**BASELINE MONITORING
DOCUMENT AND AS-BUILT
BASELINE REPORT**
Final

LYON HILLS MITIGATION SITE

Subject: Draft As-Built Baseline Monitoring Report (MY0) for the
Lyon Hills Mitigation Site
Yadkin River Basin – CU# 03040101
Wilkes County
DMS Project ID No. 100085
Contract #. 7620

On July 16, 2021, Wildlands Engineering received comments from the North Carolina Division of Mitigation Services (DMS) regarding the Draft As-Built Baseline Report dated June 11, 2021. The following letter documents DMS feedback and Wildlands' corresponding responses and revisions to the As-Built Report.

Figure 2. Project Component/Asset Map
 Lyon Hills Mitigation Site
 DMS Project No. 100085
 Monitoring Year 0 - 2021

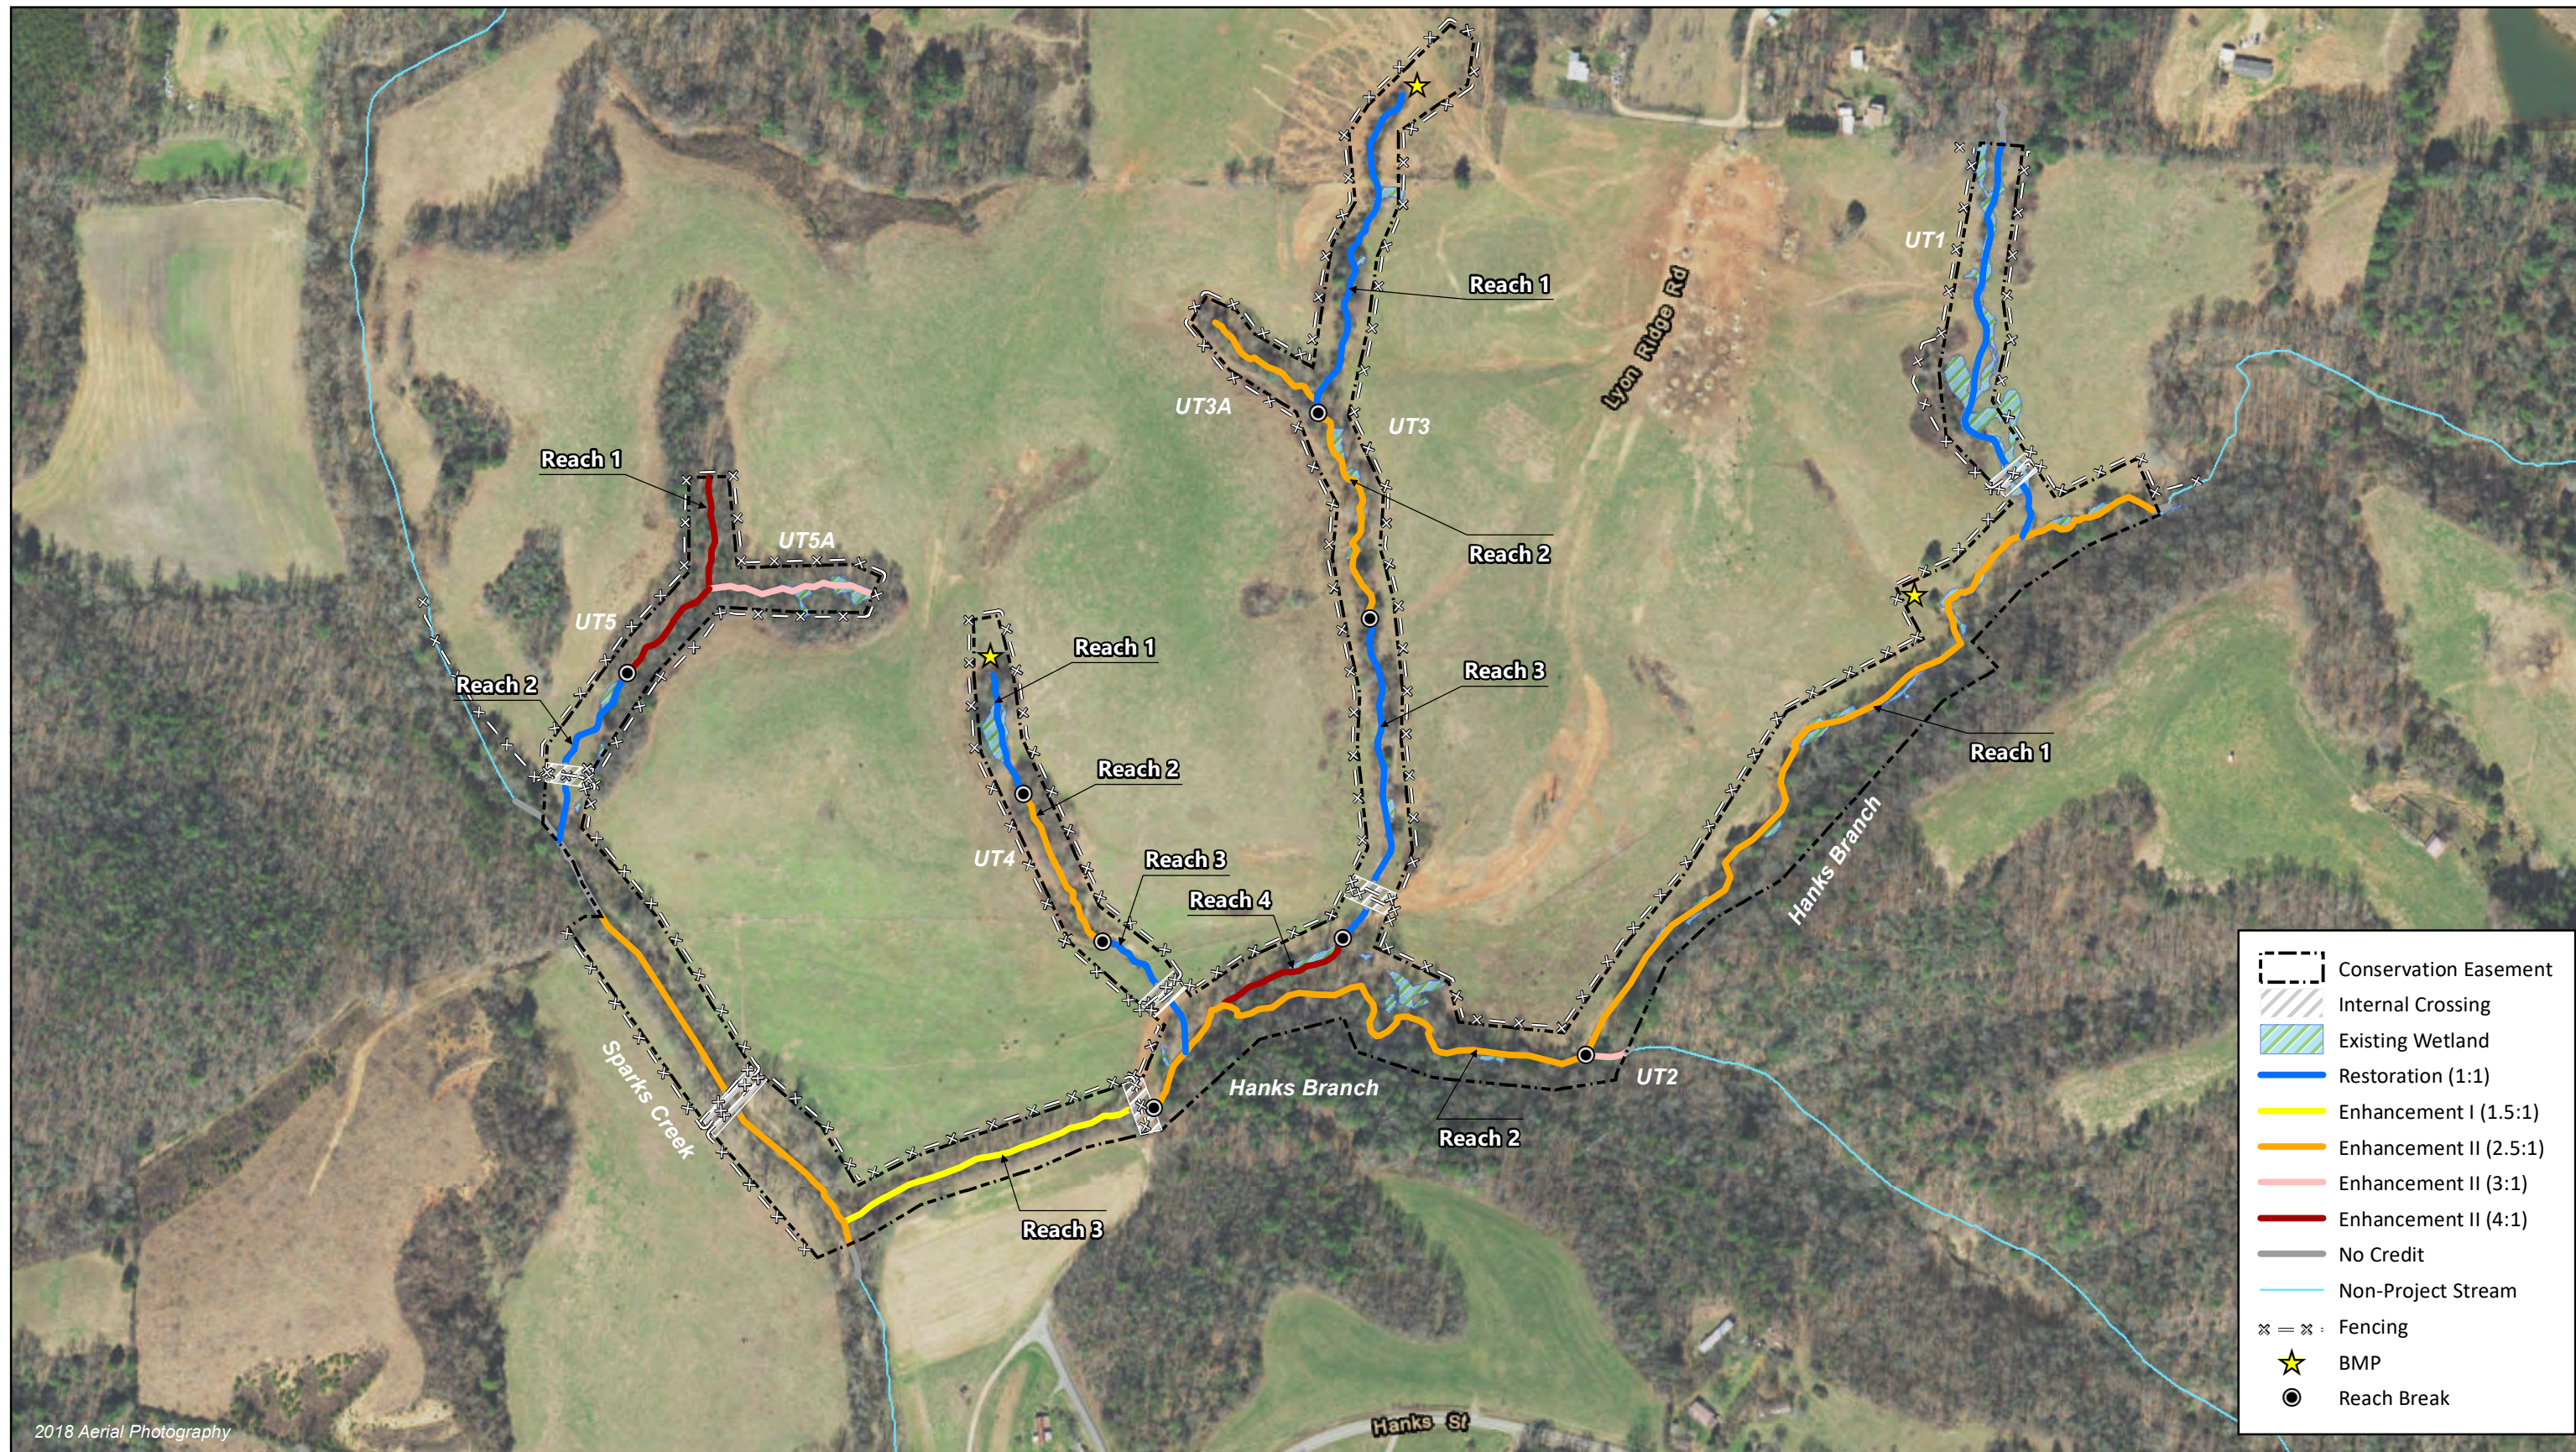
Table 1 Project Credits: Project credits are established in the Mitigation Plan. The EII credits showing in the As-Built have been increase from 2,100.450 to 2,115.650 SMU. Please review the credits presented

in the two documents and insure they are consistent, utilize the appropriate credit determination and describe any deviations.

Response: SMUs have been updated to reflect the Mitigation Plan for a total of 5,304.783 stream credits. This change has also been reflected in Figure 2, Figure 3, and Figure 3b.
